# Sigenergy Energy Controllers voluntary recall – affected approved inverters and batteries

To help resolve the issue, Sigenergy submitted a component change request to the Clean Energy Council with a new OT terminal-style AC connection design for all affected CEC listed products. This component change was approved.

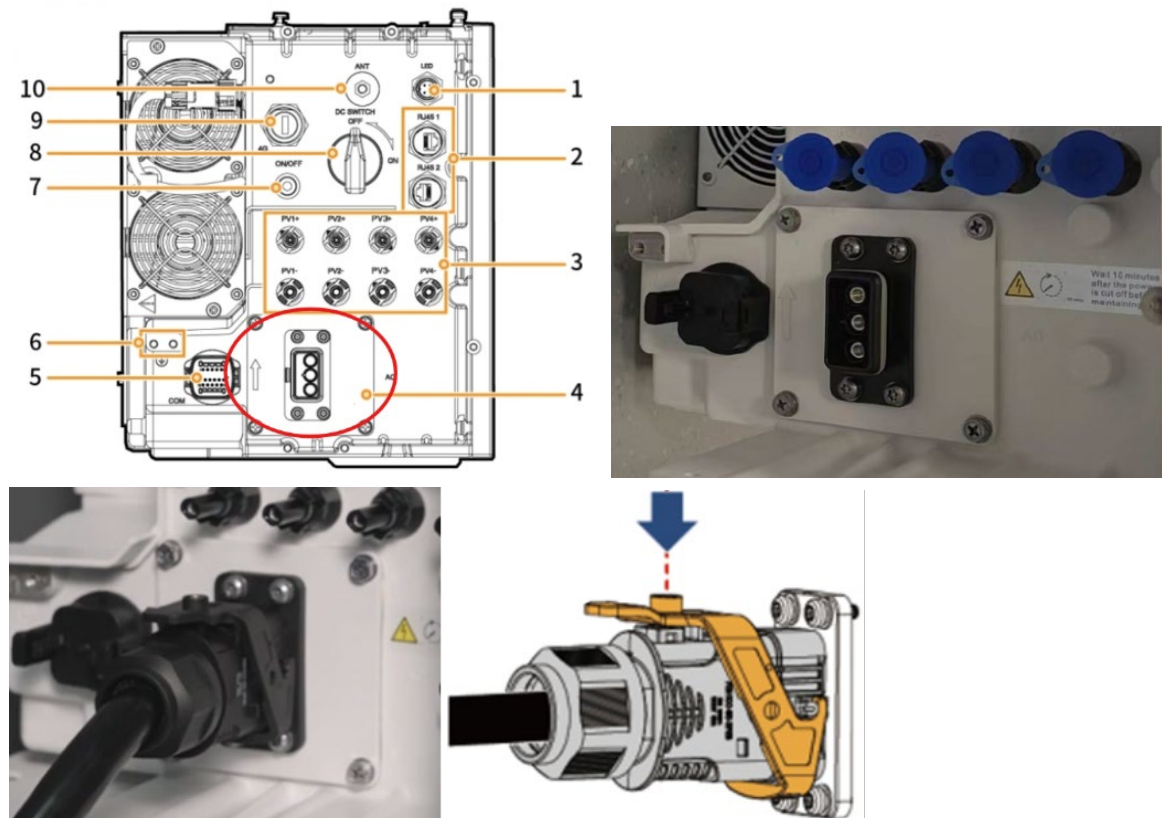
**The voluntary recall only affects the models listed below with the quick connect AC plug components requiring ferrules and crimping.**

The affected units can be identified by one of the following model numbers and the type of AC connection on the left side of the inverter.

The quick-connect AC plugs (requiring ferrules and crimping) on recalled models look like this:

The new models with OT terminal-style AC connections look like this:
